## 1.4. TECHNICAL REQUIREMENTS

#### **1.4.3. Lot 1 Site 2: BGLB 1.2 Masri Livestock Aabdeh (Akkar)**

##### **1.4.3.1 Site description (please refer to amendments in red)**

**Overview of Masri livestock (existing and planned extension), indicating the proposed biogas plant location**

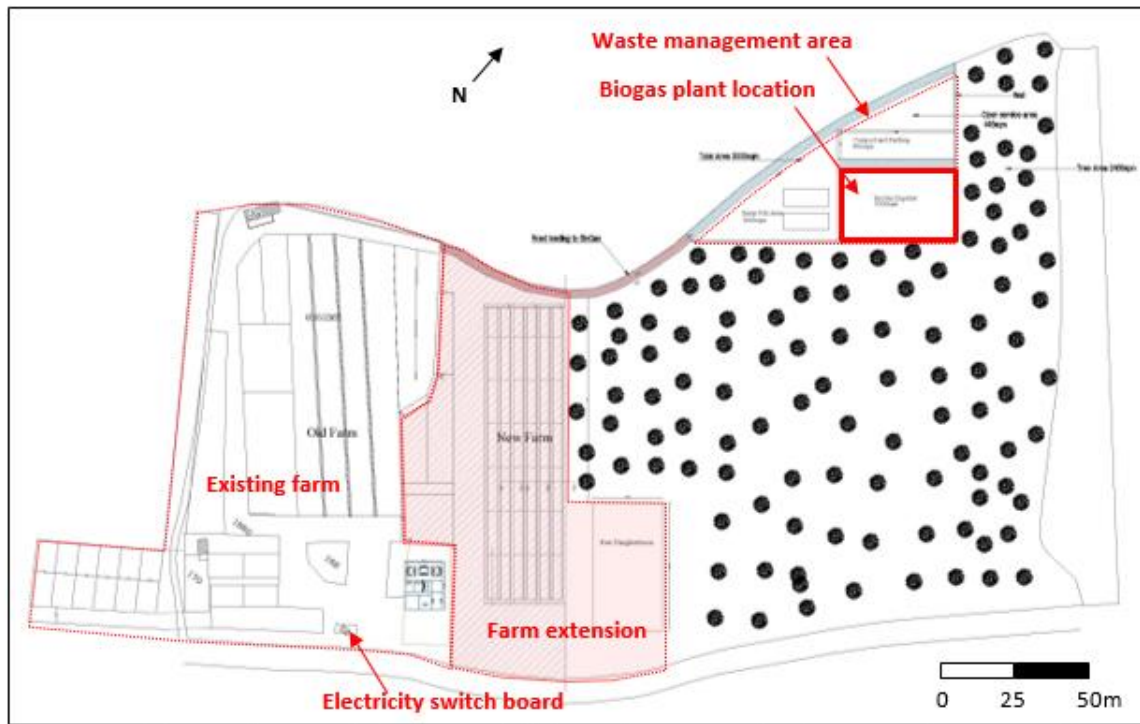
The company has decided to develop a new plot for the management of farm wastes (see map below). A new manure tank and separator will be constructed there, as well as a composting area. For the biogas plant, an area of 25x40m has been reserved.
